PREDATOR FIRMWARE V37 RELEASE NOTES

Revision: 1.0

Date: Apr. 29, 2011

Ascent Rate Bar Graph:

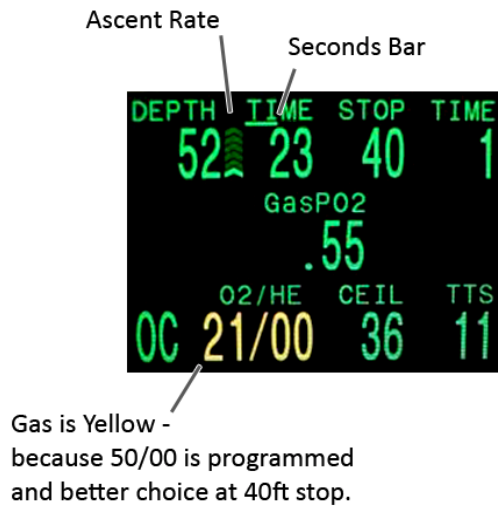
The ascent rate bar graph has moved to beside the depth. The look has also changed to up arrow indicators.

The ascent rate bars display the current ascent rate. Each bar represents 10 ft/min (3m/min).

Semi-Closed Dual PPO2/FiO2 display:

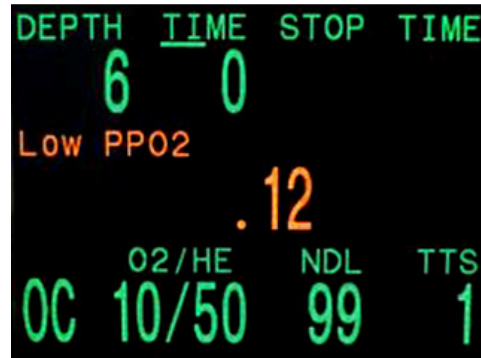
When in semi-closed mode, there is a new option to show both PPO2 and FiO2 simultaneously on the main screen.

New Warnings:

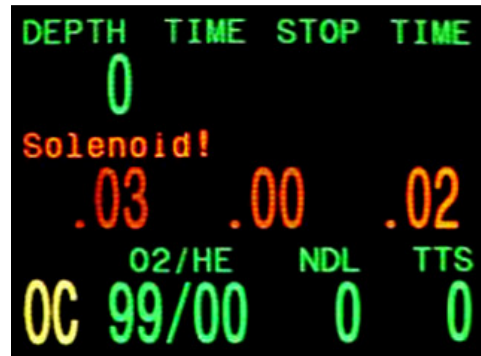
For a few serious situations, warnings will now be displayed in red on the center line.

These warnings only need to be confirmed once. After that, they will come and go as they occur.

There are currently 3 warnings that appear here:

Low PPO2: PPO2 has been less than 0.16 for more than 10 seconds.

High PPO2: PPO2 has been higher than 1.65 for more than 10 seconds.

Solenoid!: The solenoid has failed to fire properly (on rebreather controllers only).

Also, note that for rebreather controllers, OC now displays in yellow.
